Value Engineering Study Final Report

Malabar Road (SR 514) PD&E Study
From East of Babcock Street (SR 507) to US 1
Brevard County, Florida

State Road 514 (Malabar Road) from Babcock Street to US 1 PD&E Study

Study Dates: August 18 – 22, 2014

RECOMMENDATION No. 11: Can we treat the no-build section to provide compensatory treatment for Basin 9 located at the intersection of SR 514 and US 1

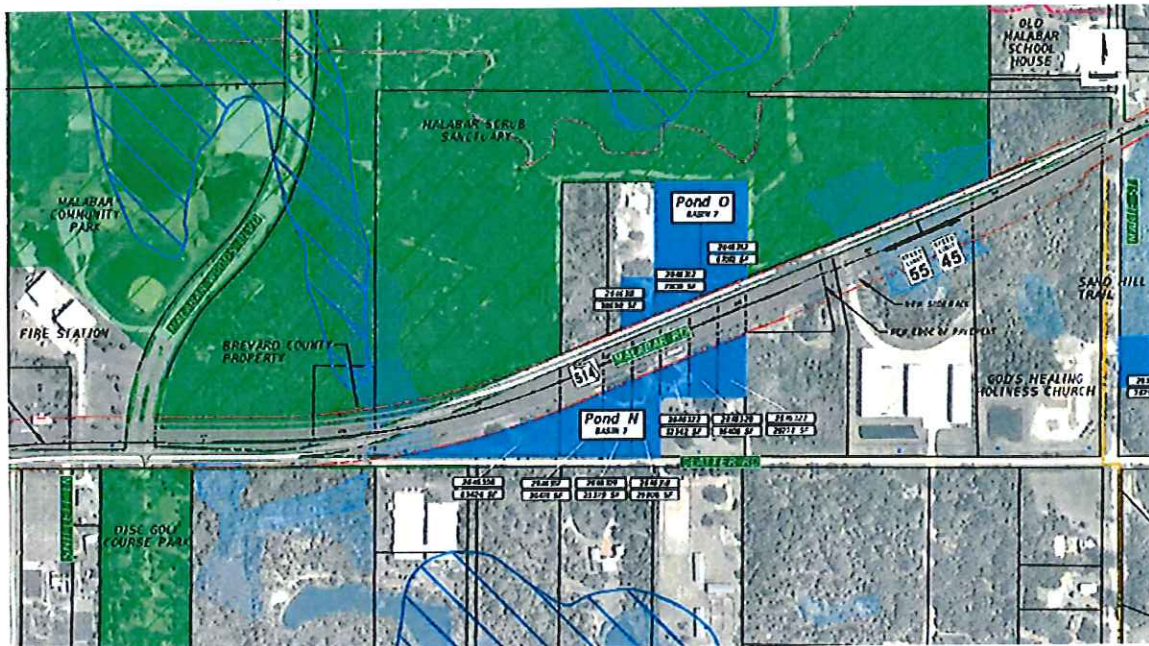
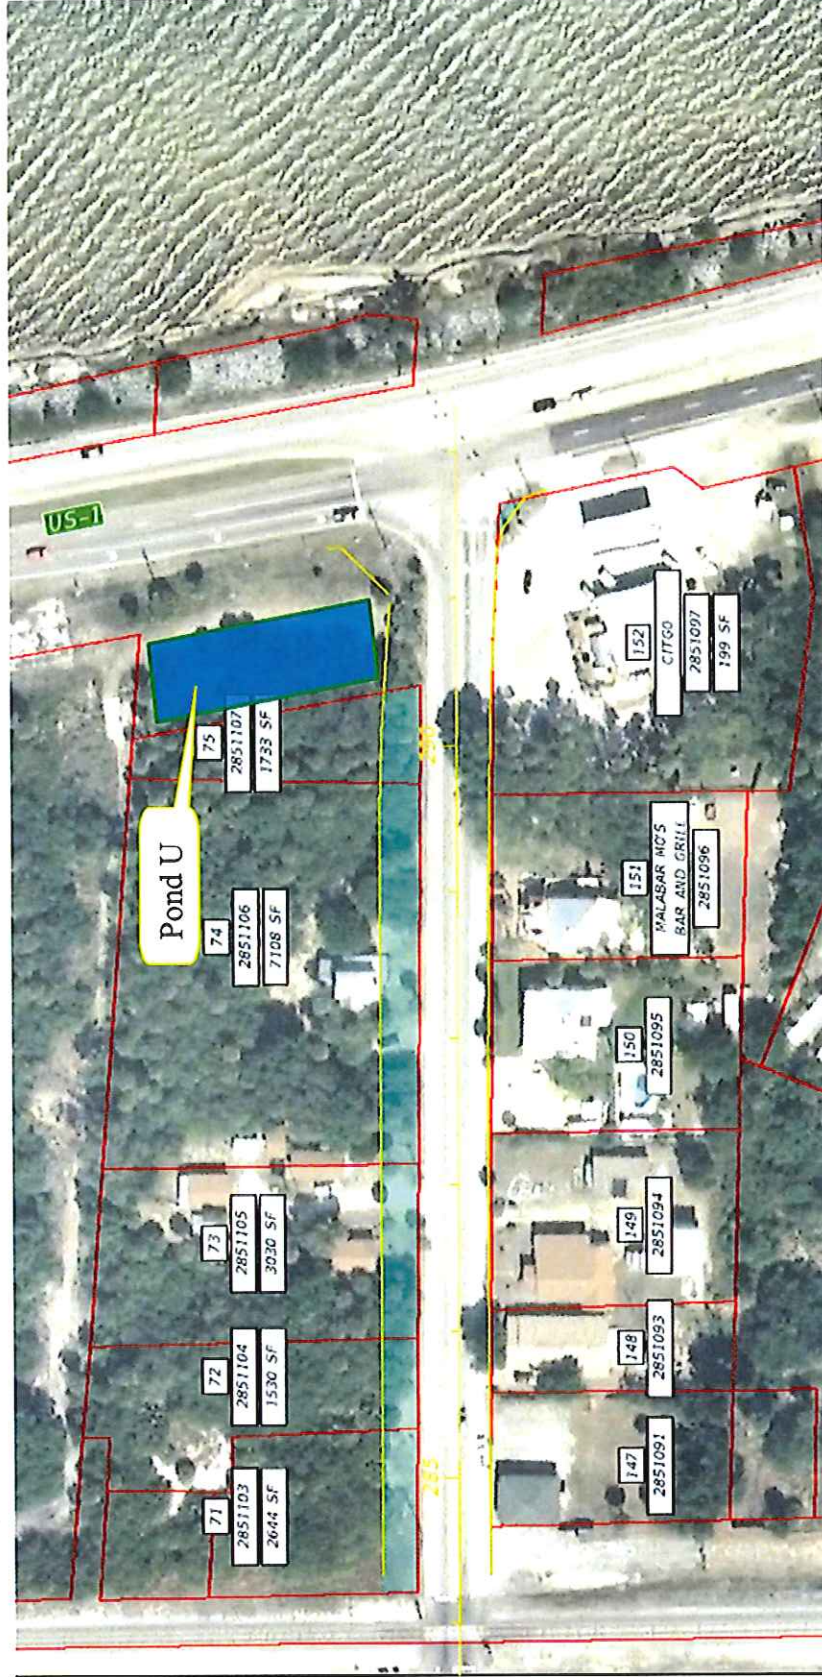
Provide compensatory treatment in Basin 7 with recommended pond alternative Pond O site that discharges east to existing ditch systems located east of Marie Street and ultimately discharges to the FDOT outfall that is located 1,000 feet south of SR 514. This outfall ultimately discharges to the Indian River Lagoon. This will provide compensatory treatment in Basin 7 that is located within the recommended no-build Segment 2 from Corey Road to Marie Street that includes a multi-use path. This will eliminate the recommended stormwater alternative Pond U site.

- Eliminates proposed Pond U site in Basin 9 where the Cultural Resource Assessment (CRAS) has identified the presence of an intact shell midden (Malabar Site, 8BR0053). A Phase II CRAS is currently recommended if any construction is proposed in the vicinity of this site to further define existing conditions.
- Provide an overall improvement to the Indian River Lagoon from a pollutant loading reduction which has been listed for phosphorus and nitrogen impairments.
- Provide a drainage alternative for recommended Pond U in Basin 9 within the same overall drainage basin, Indian River Lagoon.

Alternative Pond U Site – within existing FDOT right-of-way; It is anticipated that the construction cost estimates for Pond U *does not* include any mitigation costs if required for potential cultural resource impacts.

Based on accepting Recommendation #12 (below), it would be better to compensate for Basin #9 in one of the two properties on the north side of Malabar east of the railroad. Two of the impacted properties in Basin 9 will likely be full acquisitions, which would allow for ponds to be located on the properties instead of being compensated for in the no build section of Malabar Road (SR 514). It would be better to provide for ponds in Basin 9 on the impacted properties east of the FEC railroad.

RECOMMENDATION No. 12: Build a pond on the two properties that we are taking on the north side of Malabar east of the railroad

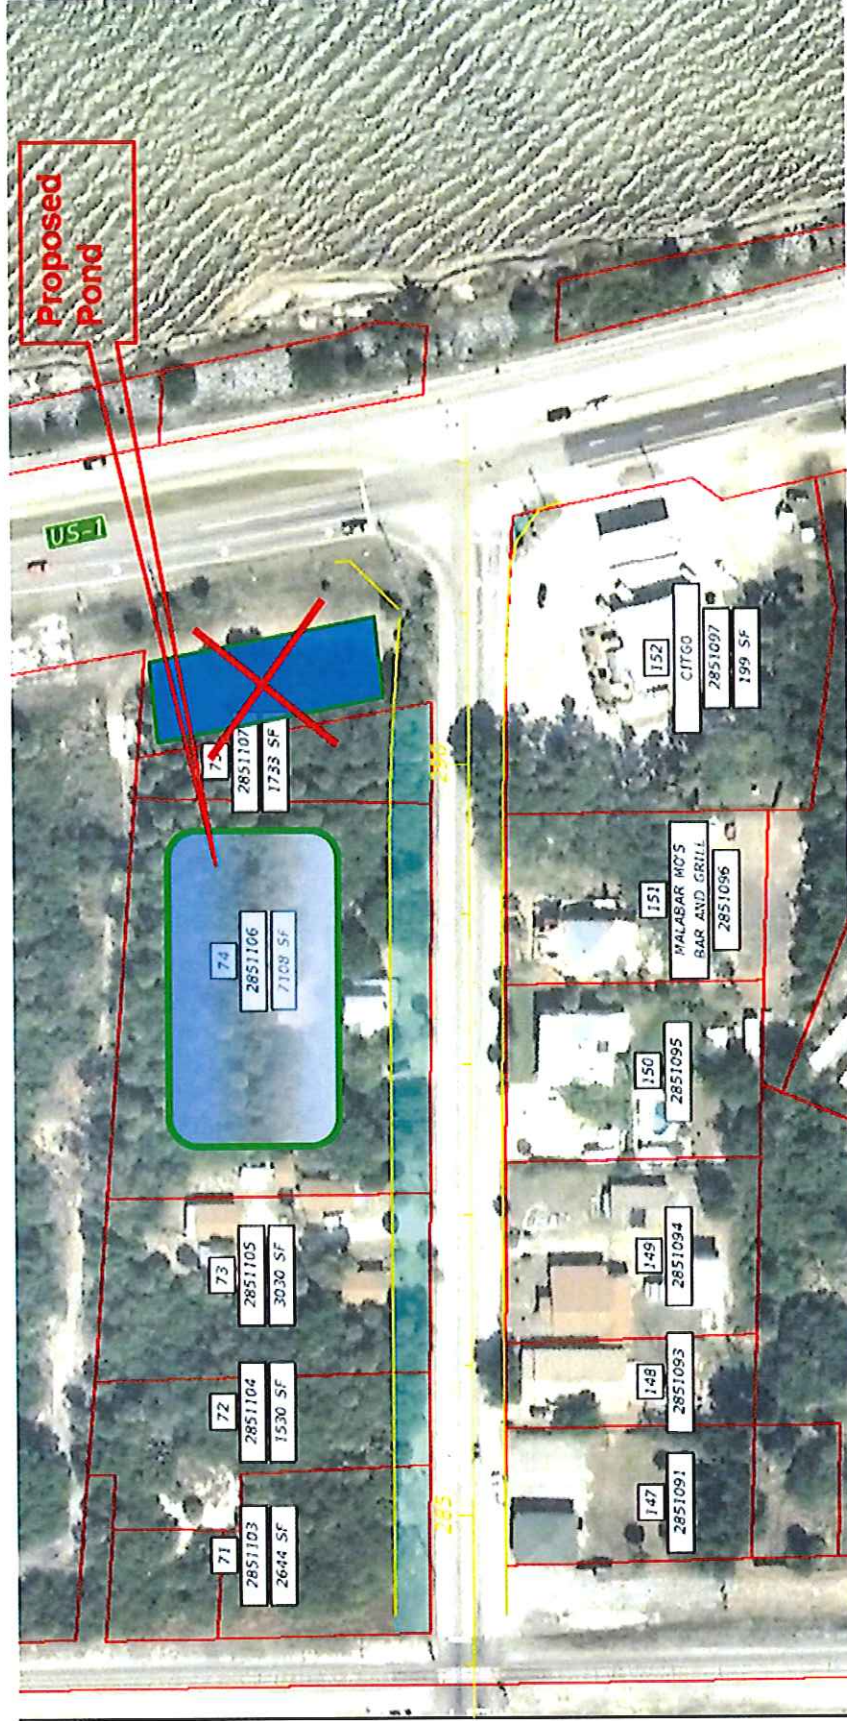
- Eliminates proposed Pond U site in Basin 9 where the Cultural Resource Assessment (CRAS) has identified the presence of an intact shell midden (Malabar Site, 8BR0053). A Phase II CRAS is currently recommended if any construction is proposed in the vicinity of this site to further define existing conditions.
- Provide an overall improvement to the Indian River Lagoon from a pollutant loading reduction which has been listed for phosphorus and nitrogen impairments.
- Provide a drainage alternative for recommended Pond U in Basin 9 within the same overall drainage basin, Indian River Lagoon.

Right of Way Cost Estimate for full parcel acquisition for Residential Parcel No. 74: \$36,000

It was the PD&E team's initial understanding that the property located on the northwest quadrant of Malabar Road and US 1 was an FDOT property, but we understand that this property may have been recently purchased by a local business owner. The PD&E team will verify this, but if this is the case, it would make sense to locate a pond on a nearby property where a full acquisition will be likely.

RECOMMENDATION No. 17: Shift alignment to the south to avoid the taking of Hospital Parking

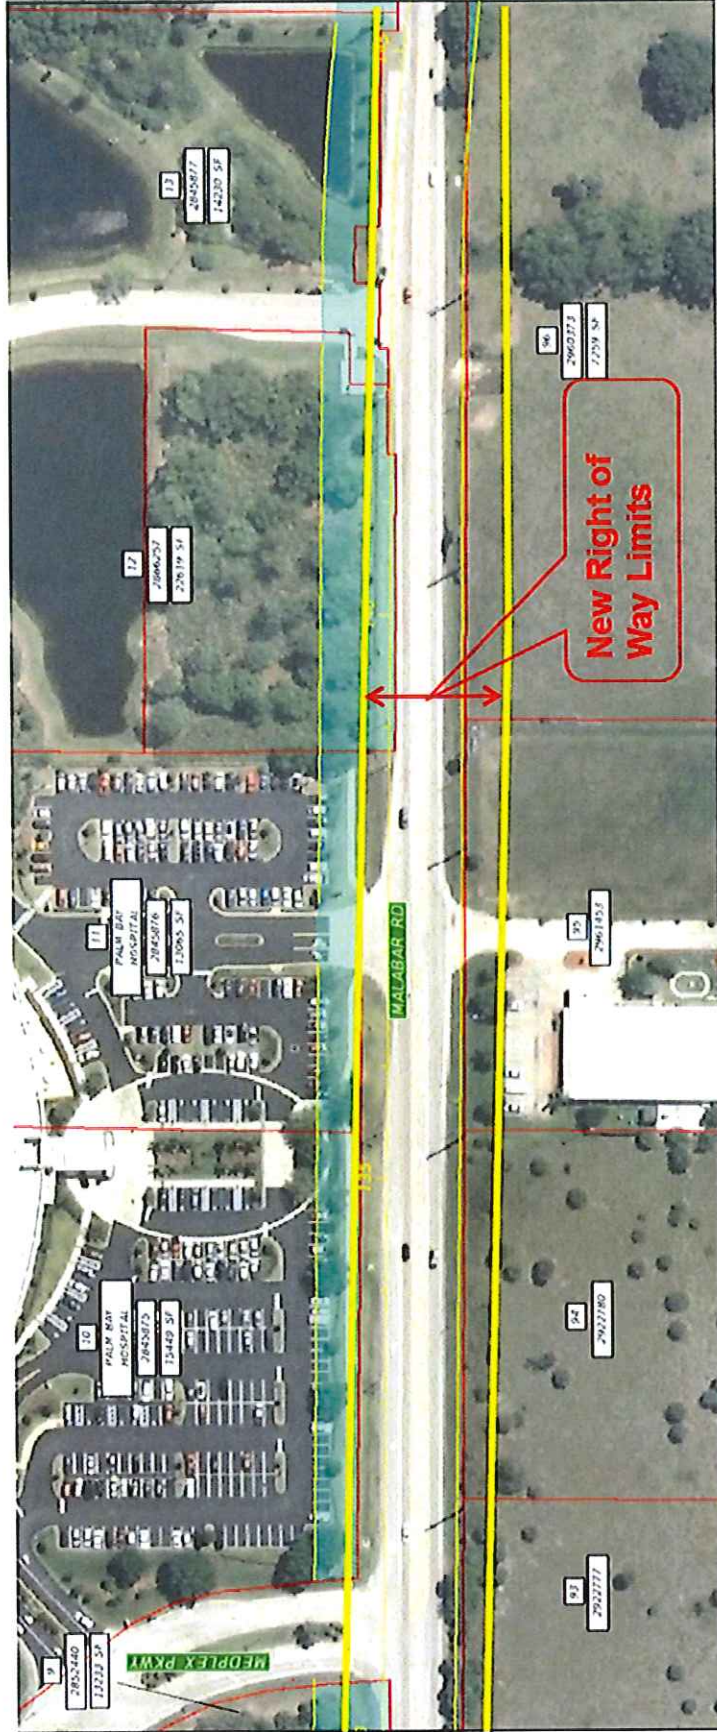
Note: At C-78 Canal [Station 125+05], existing Conc. Box Culvert 8 ft. x 4 ft. with length of 62 feet may need to be extended to the south to accommodate the shift of the road.

The VE team's cost analysis show that it will be cheaper to impact the large transmission poles than to impact the front parking of the Palm Bay Hospital. In this case, it would be worth the shift in alignment in this section.
